HISTORIC AND DESIGN REVIEW COMMISSION

December 06, 2017

HDRC CASE NO: 2017-595
ADDRESS: 205 OSTROM
LEGAL DESCRIPTION: NCB 6938 BLK LOT 1&2
ZONING: R-4 CD, H, RIO-1
CITY COUNCIL DIST.: 1
DISTRICT: River Road Historic District
APPLICANT: Tobias Stapleton
OWNER: Tobias Stapleton
TYPE OF WORK: Construction of a two story, rear accessory structure and rehabilitation of the historic structure
APPLICATION RECEIVED: November 3, 2017
60-DAY REVIEW: January 2, 2017
REQUEST:

The applicant is requesting conceptual approval to construct a two story, rear accessory structure. The existing, one-story residence on the property will be retained and rehabilitation plans submitted at a future date.

Front Elevation scale: 1/8" = 1' - 0"

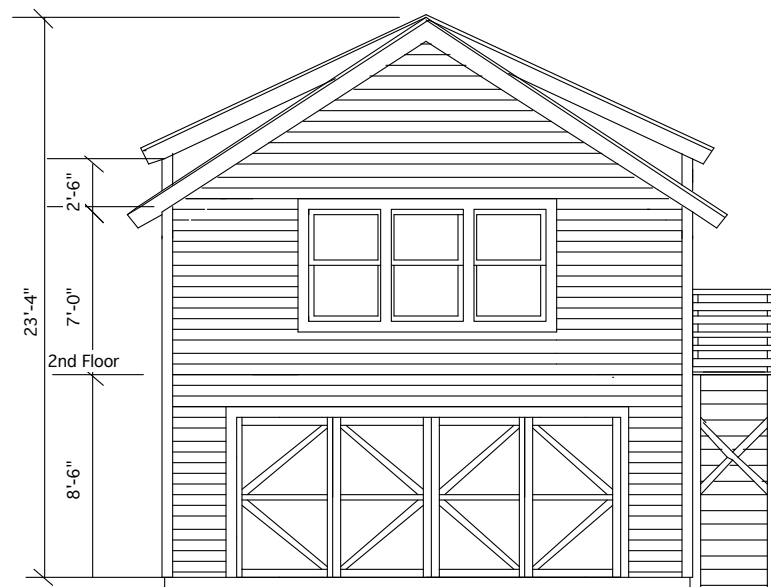
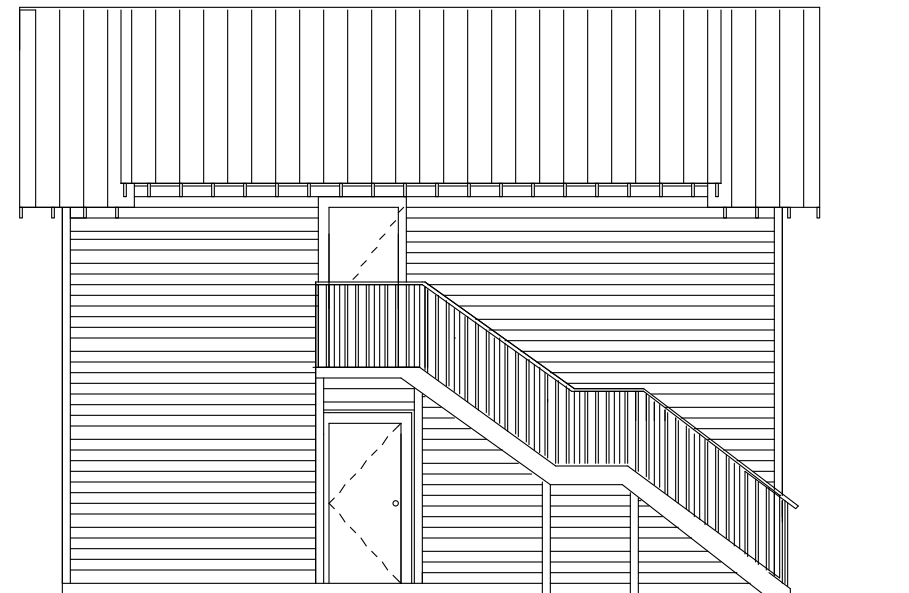
- f. **ACCESSORY STRUCTURE** – To the rear (northwest) of the primary historic structure, the applicant has proposed to construct a two story accessory structure to accommodate vehicular parking as well as a second level dwelling unit. The proposed accessory structure features an overall profile and massing that is greater than that of the primary historic structure, which features one story; however, staff finds that the proposed structure is appropriate given the proposed roof form and architectural details, which not only reduce its perceived massing, but also relate it to historic structures found throughout the district.

- i. **MATERIALS** – Regarding materials, the applicant has proposed materials that consist of an asphalt shingle roof, double hung wood windows, wood or Hardi board siding. Staff finds the proposed materials appropriate; however the proposed siding should feature an exposure of four inches and a smooth finish to remain consistent with the Historic Design Guidelines.

- ii. That the single garage door be eliminated and a two-stall configuration with two separate door be used instead. The doors must feature materials and a profile consistent with historic examples found in the district.
- iii. That a detailed plan for rehabilitation be submitted to staff prior to final approval of the proposed new construction.
- iv. ARCHAEOLOGY- Archaeological investigations may be required. The archaeological scope of work should be submitted to the OHP archaeologists for review and approval prior to beginning the archaeological investigation. The development project shall comply with all federal, state, and local laws, rules, and regulations regarding archaeology.

Essence Double Hung Window

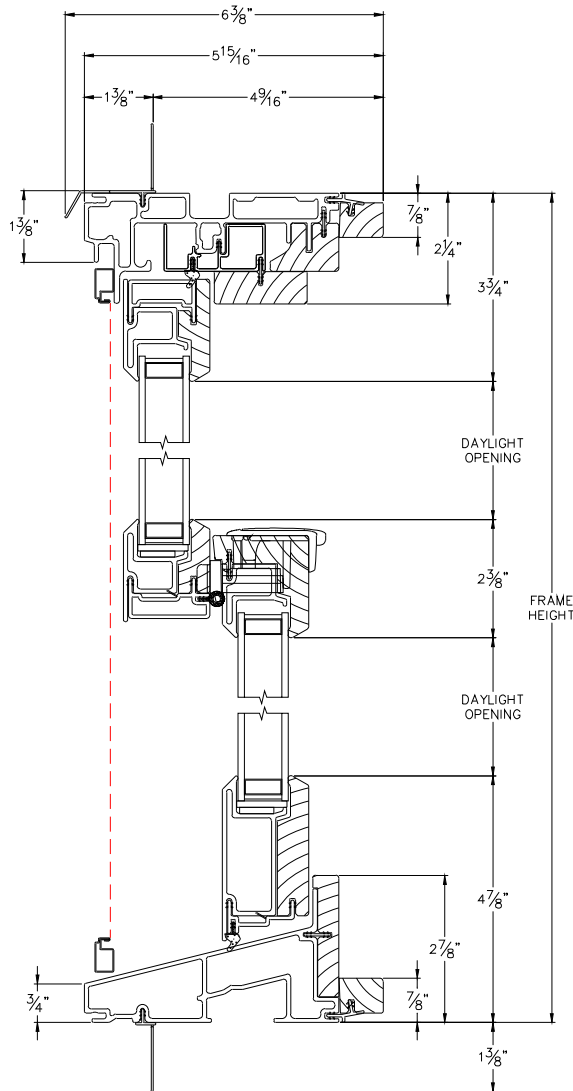
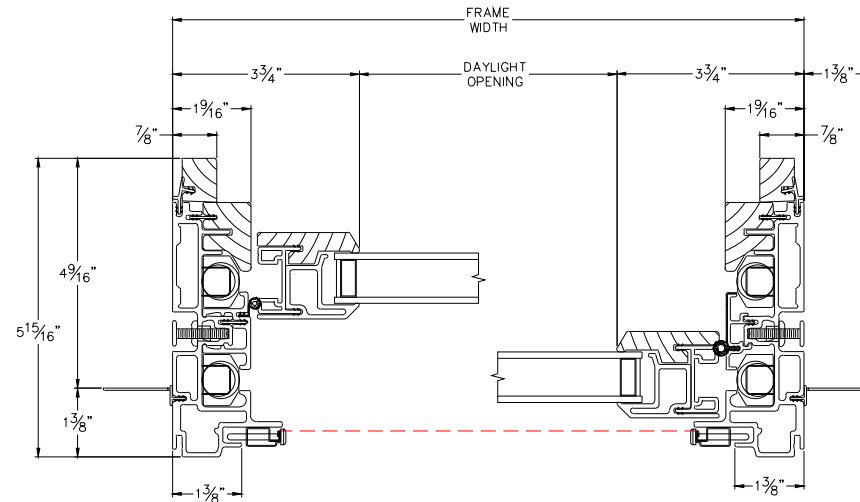
- i. That the applicant install wood or aluminum clad wood windows should be installed that feature meeting rails that are no taller than 1.25” and stiles no wider than 2.25”. White manufacturer’s color is not allowed, and color selection must be presented to staff. There should be a minimum of two inches in depth between the front face of the window trim and the front face of the top window sash. This must be accomplished by recessing the window

sufficiently within the opening or with the installation of additional window trim to add thickness. Window trim must feature traditional dimensions and an architecturally appropriate sill detail. Window track components must be painted to match the window trim or concealed by a wood window screen set within the opening.
